Subject: Bid Package #1
Borel Middle School HVAC Replcmt-DSA 01-119557
College Park Elementary School HVAC Replcmt-DSA 01 119530
Meadow Heights Elementary School HVAC Replcmt DSA 01-119554
North Shoreview Montessori School HVAC Replcmt DSA 01-119526
San Mateo - Foster City School District

ADDENDUM NO. 1

Subject: Borel Middle School HVAC Replacement
San Mateo - Foster City School District
Aedis Project No. 2021005
DSA Application #01-119557

ADDENDUM NO. 1

SHEET # AD1-
A2.01

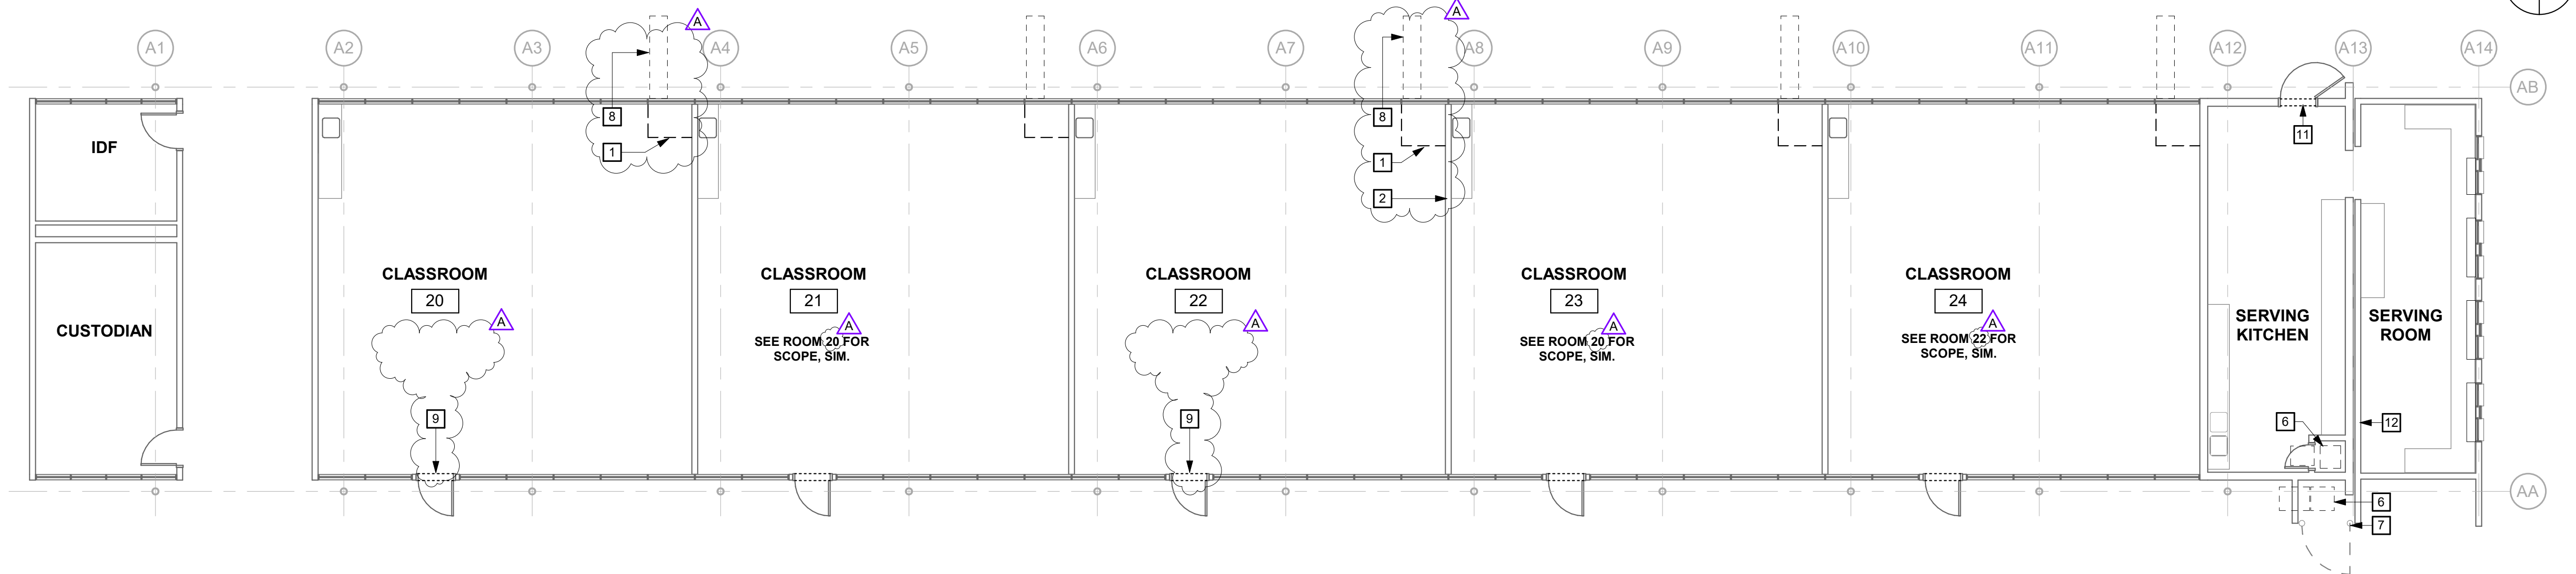
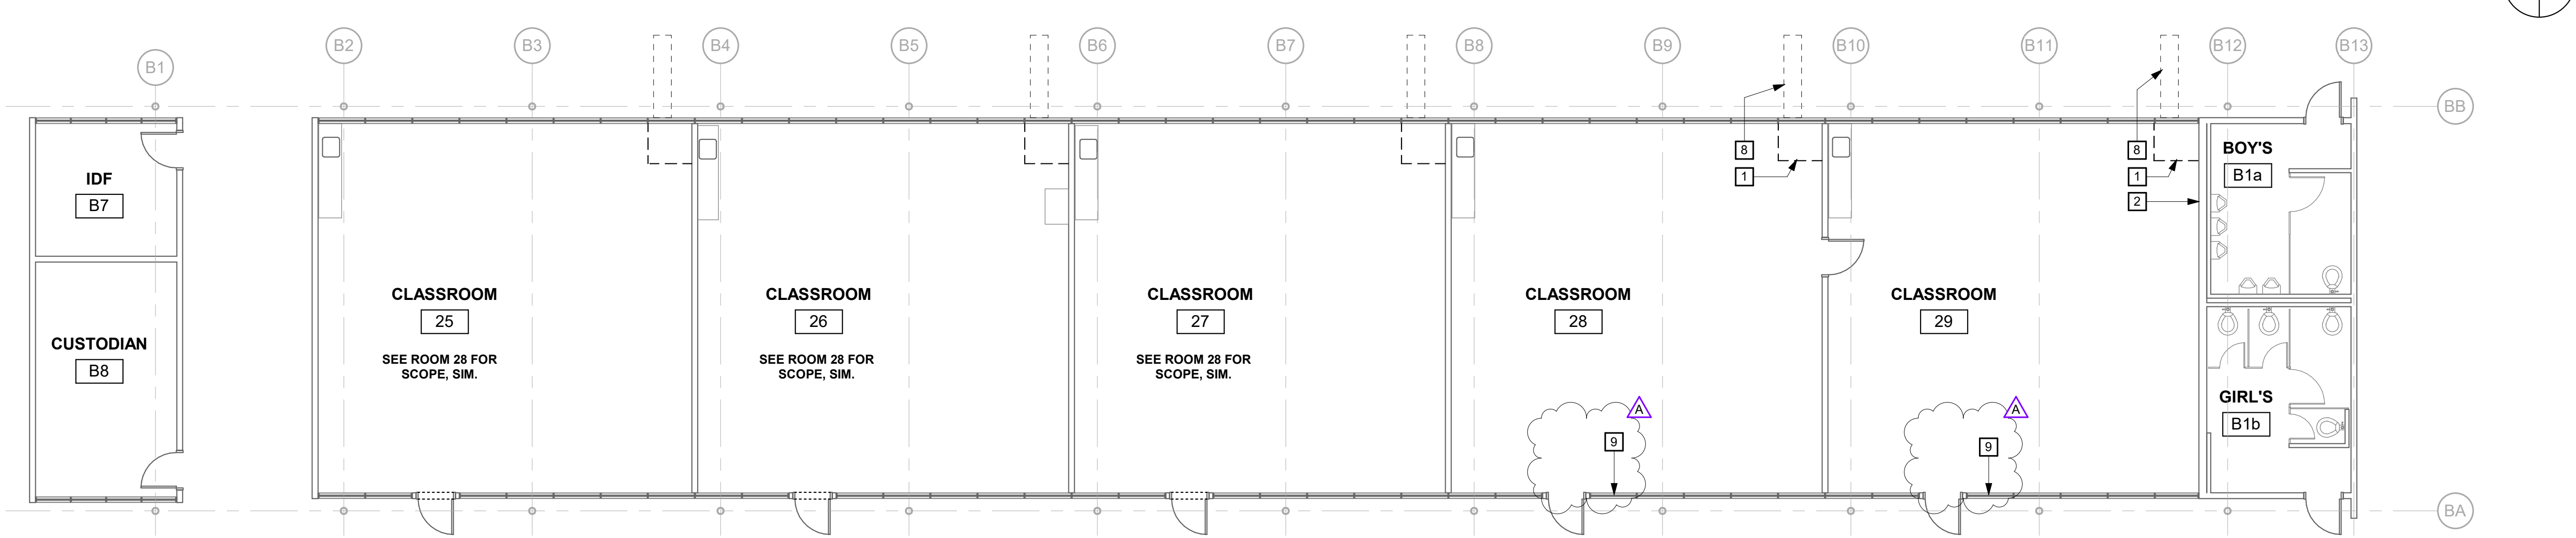
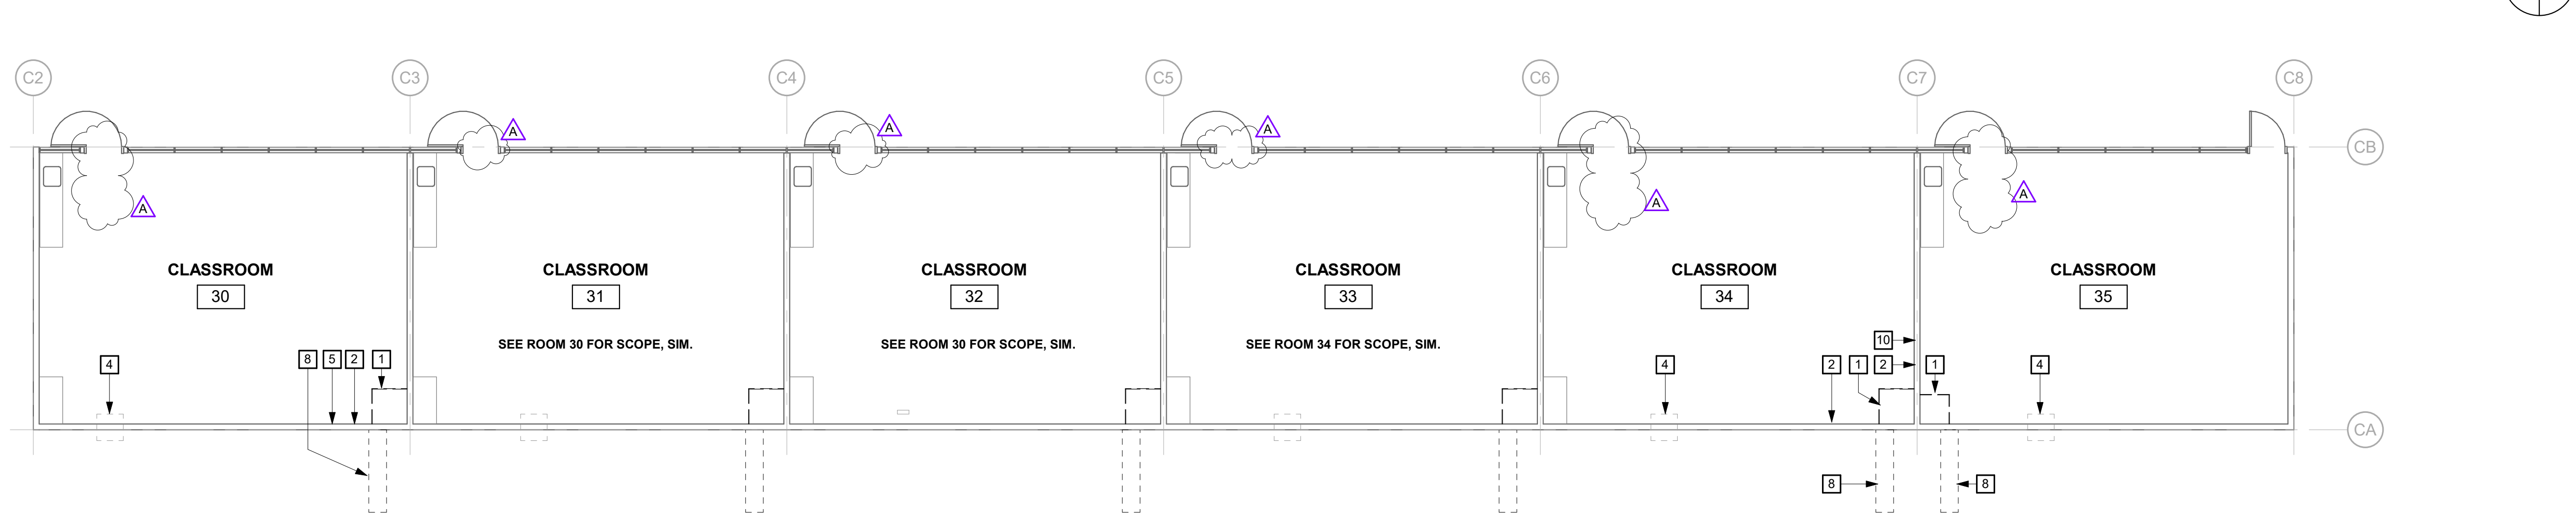
- Revise: Reference room 20 for similar scope where occurs in Demolition Floor Plan 2/A2.01 per AD1-A2.01
- Revise: Keynote scope for classrooms 20 and 22 in Demolition Floor Plan 2/A2.01 per AD1-A2.01
- Add: Keynote 9 in Demolition Floor Plan 3/A2.01 per AD1-A2.01
- Remove: Keynote 9 in Demolition Floor Plan 4/A2.01 per AD1-A2.01
- Add: General Sheet Note #J PER AD1-A2.01

SHEET # AD1-
A2.02

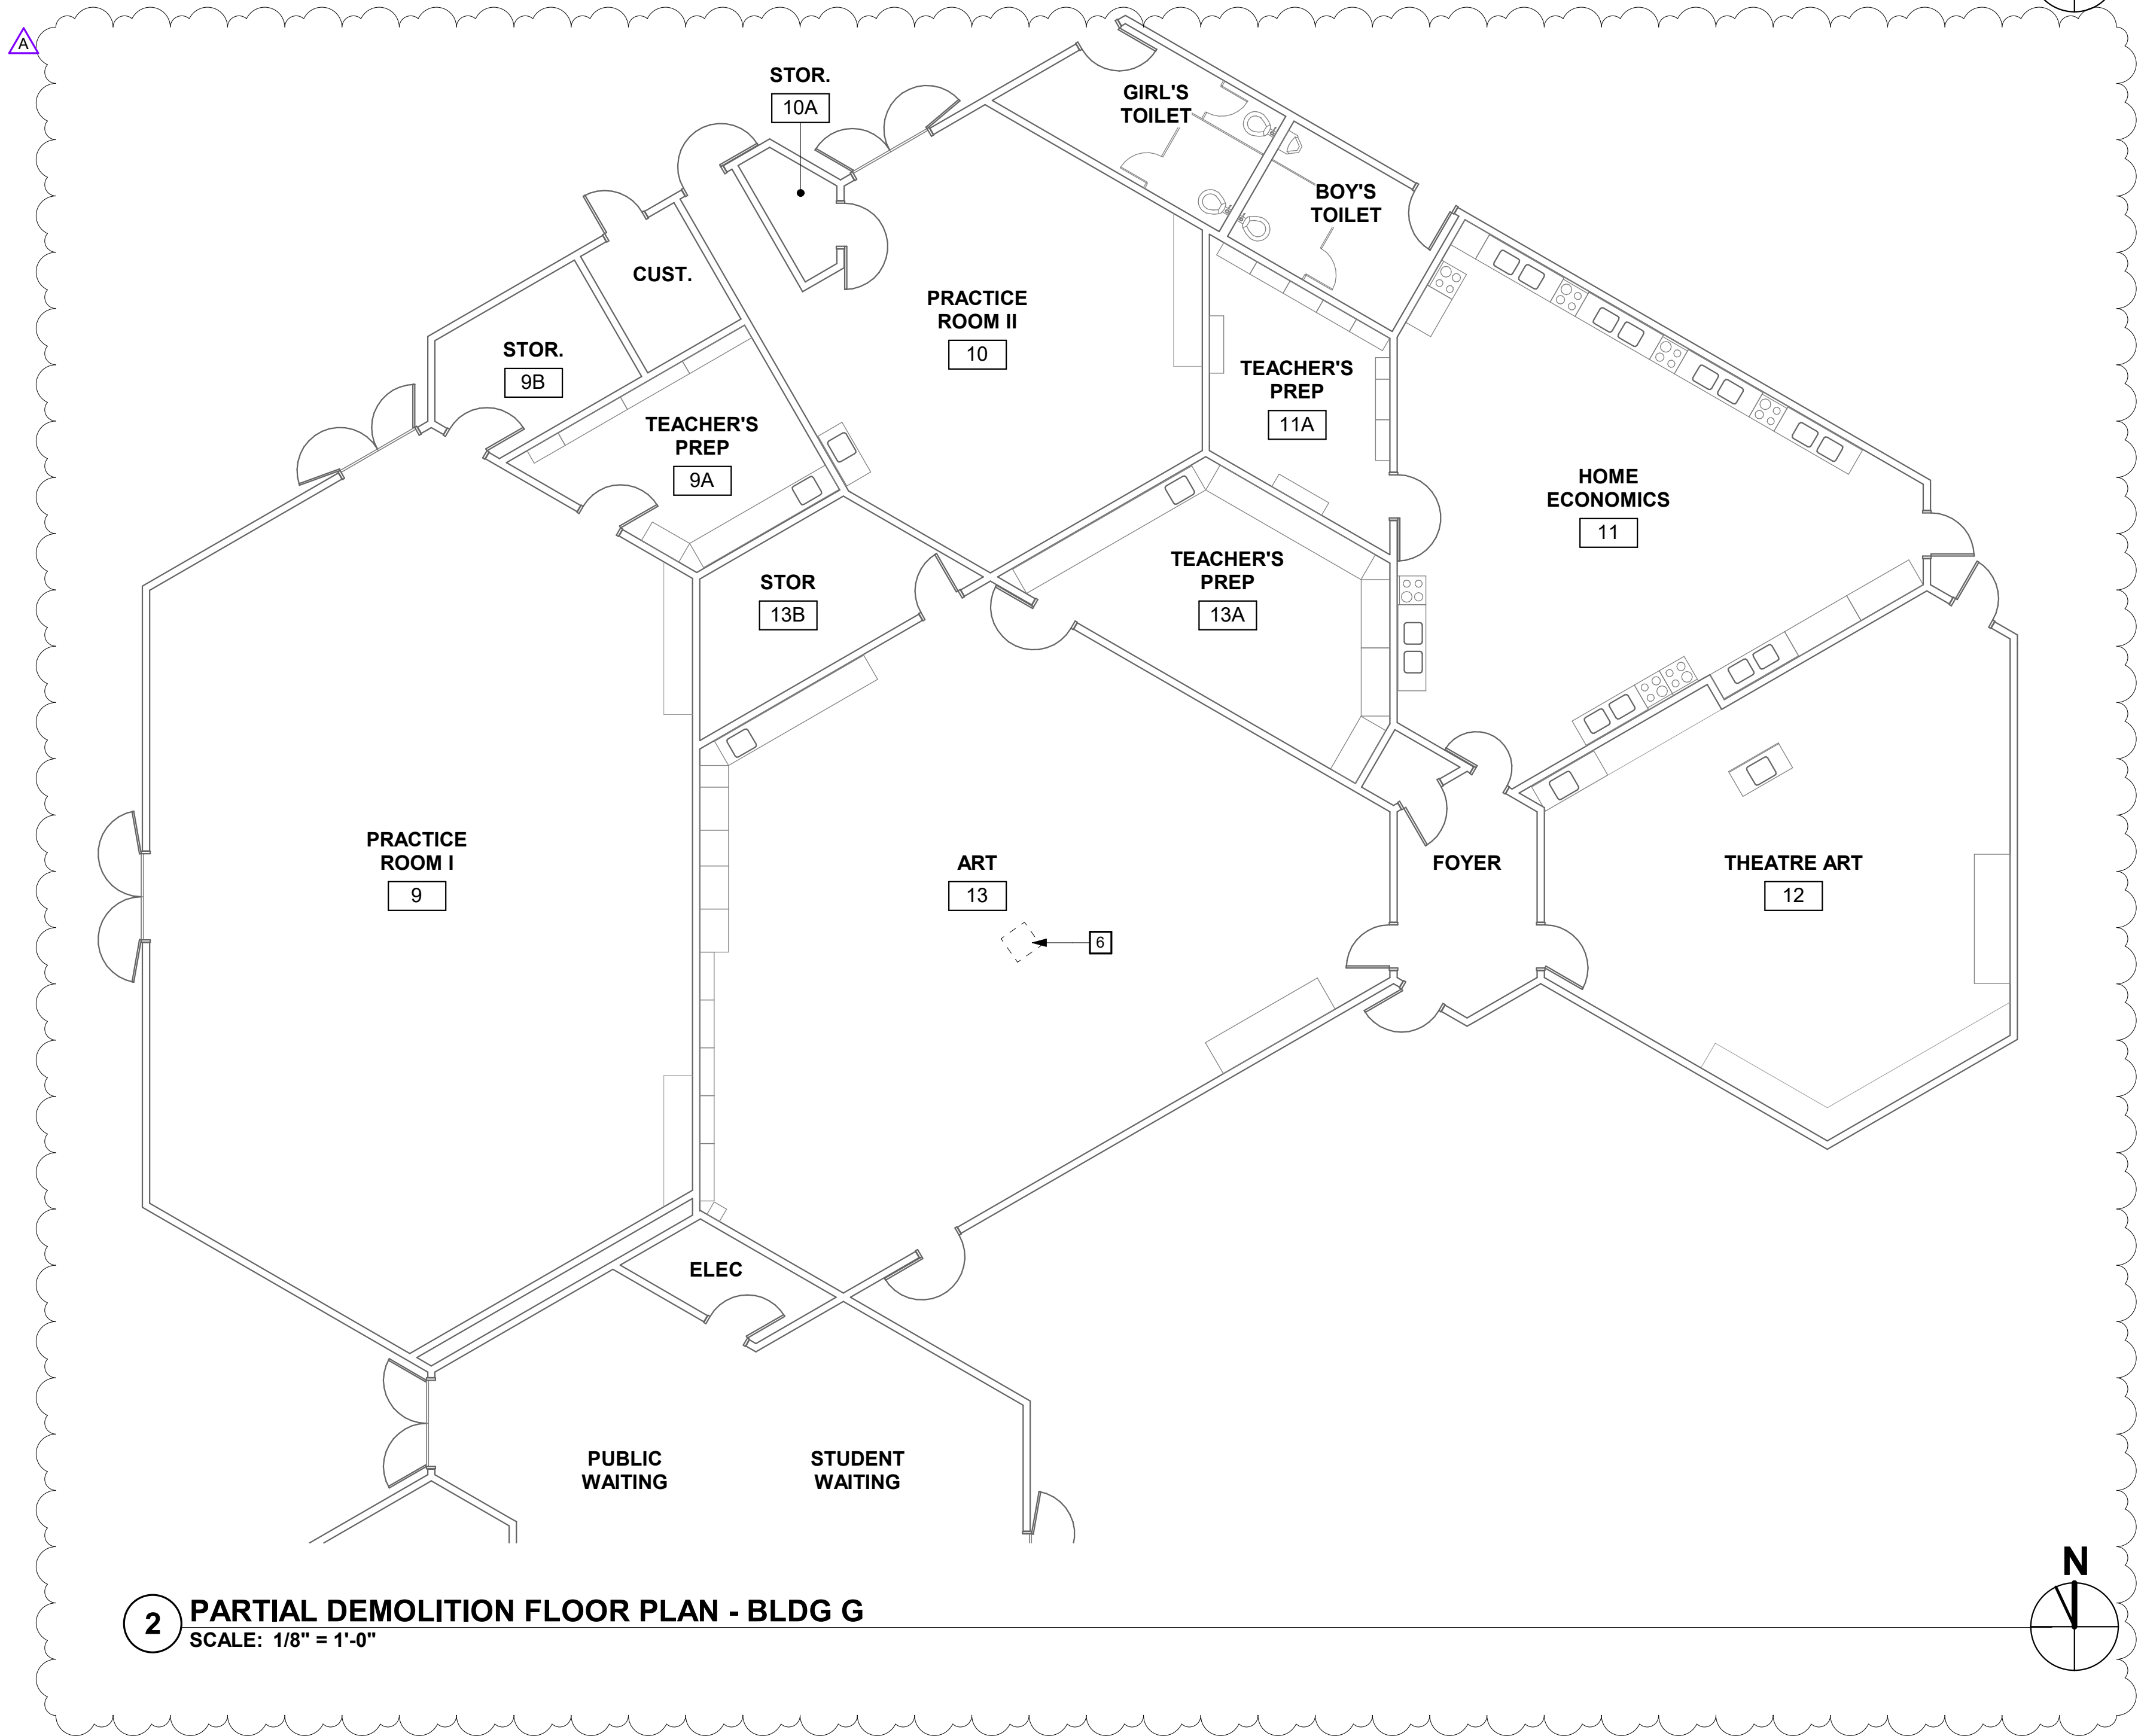
- Add: View 2/A2.02 PARTIAL DEMOLITION FLOOR PLAN – BLDG. G per AD1-A2.02
- Add: General Sheet Note #J per AD1-A2.02
- Revise: Remove and relocate as occurs keynote #5 at Demolition Floor Plan 1/A2.02 per AD1-A2.02
- Revise: Demolition Floor Plan Keynote #5 per AD1-A2.02
- Add: Demolition Floor Plan Keynotes #6 per AD1-A2.02
